Palo Verde Nuclear
Generating Station

102-05116-CDM/TNW/RAB
July 9, 2004

**Subject: Palo Verde Nuclear Generating Station (PVNGS)
Units 1, 2 and 3
Docket Nos. STN 50-528, 50-529 and 50-530
Request for a License Amendment to Support Replacement of Steam
Generators and Updated Power Operations in Units 1 and 3, and
Associated Administrative Changes for Unit 2**

Figure 3.4.1-1, (Page 1 of 2)
Reactor Coolant Cold Leg Temperature vs. Core Power Level

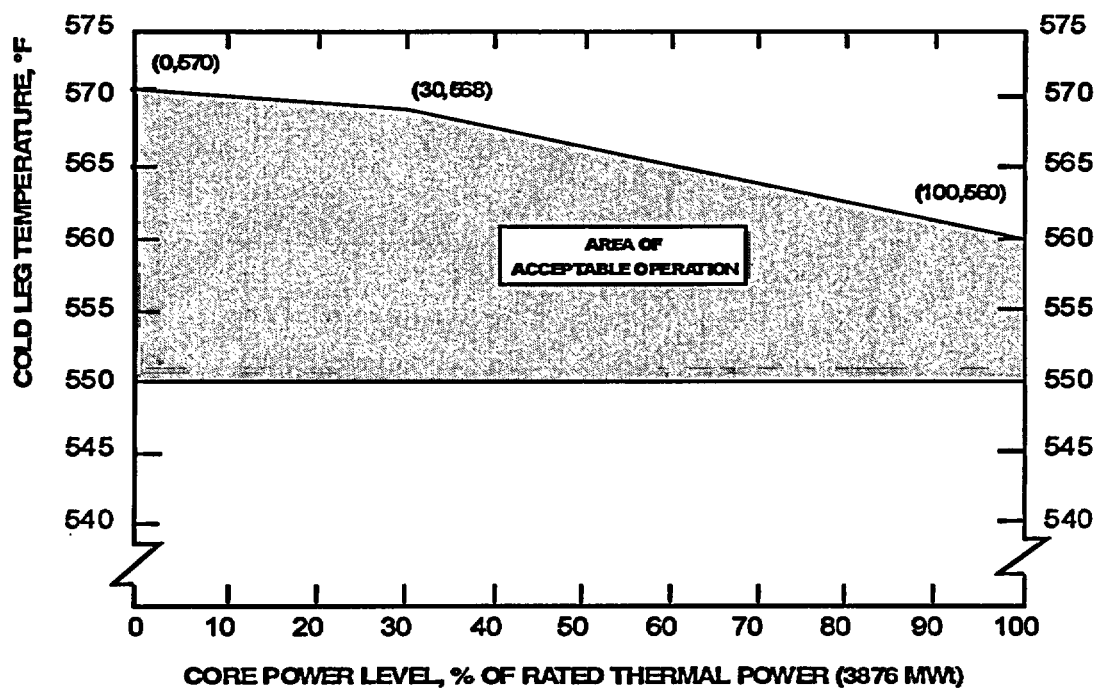
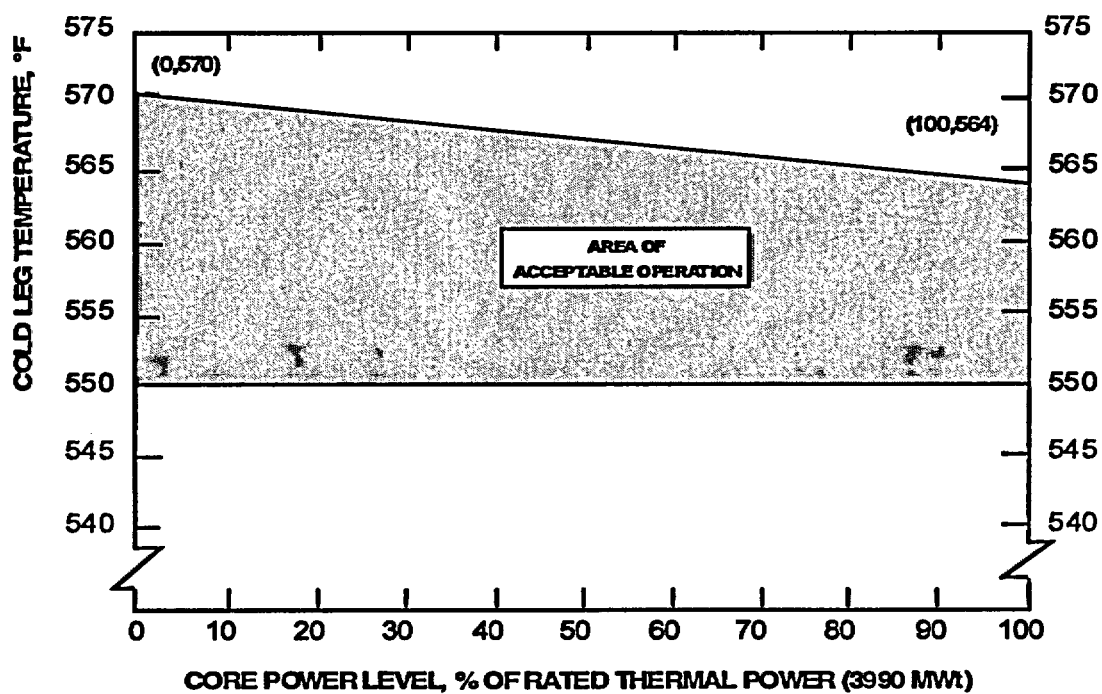
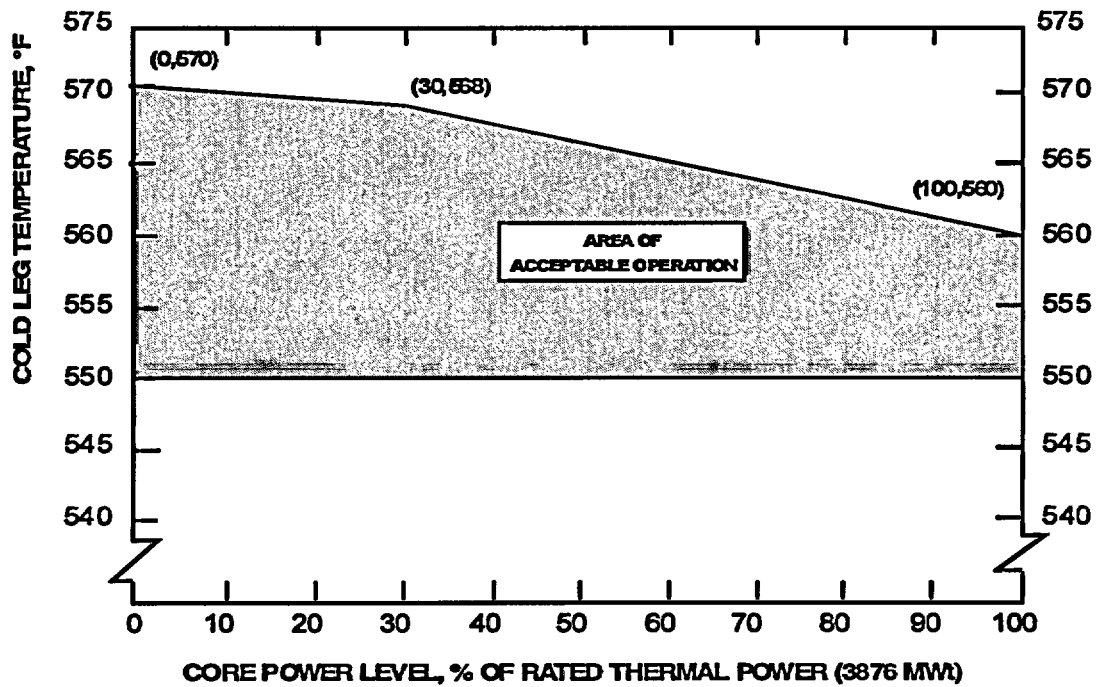
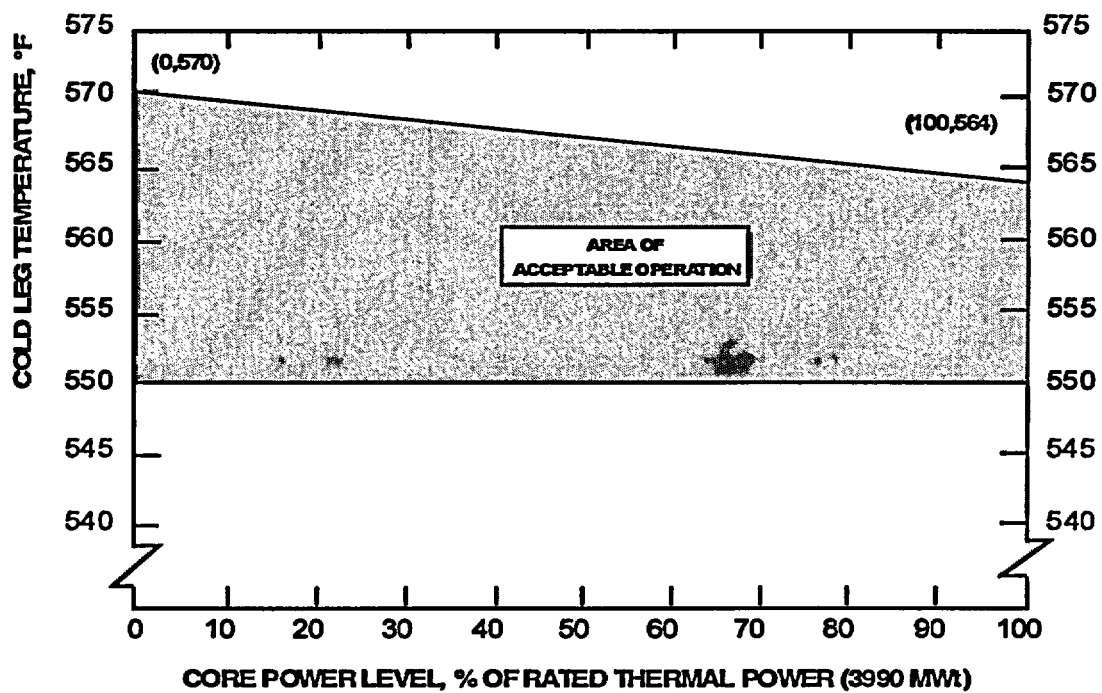
7. Revise Figure 3.4.1-1 (Page 1 of 2 and Page 2 of 2), Reactor Coolant Cold Leg Temperature vs. Core Power Level, to change the upper limit in the area of acceptable operation for units licensed to operate at 3990 MWt RTP. Page 1 of 2 would apply to units operating at 3876 MWt RTP, and page 2 of 2 would apply to units operating at 3990 MWt RTP. The new upper limit line would allow a cold leg temperature of 570 °F at 0% power, decreasing linearly to 564 °F at 100% power. The upper limit line of Figure 3.4.1-1, in the current TS, decreases linearly from 570 °F at 0% power to 568 °F at 30% power. At 30% power the current figure then decreases linearly from 568 °F to 560 °F at 100% power. The increase in cold leg temperature at 100% power will allow a more optimum main steam pressure for turbine operation. Both the power uprate and RSGs affect this specification.

Figure 3.4.1-1, Reactor Coolant Cold Leg temperature vs. Core Power Level, referenced in LCO 3.4.1, RCS Pressure, Temperature, and Flow Departure from Nucleate Boiling (DNB) Limits, provides parametric limits to ensure that the actual value of the reactor coolant cold leg temperature is maintained within the range of values used in the safety analysis. The safety analysis supporting this requested amendment uses the proposed new allowable cold leg temperature range (550 °F to 570 °F), and this proposed change maintains the basis for the cold leg temperature limits.⁴
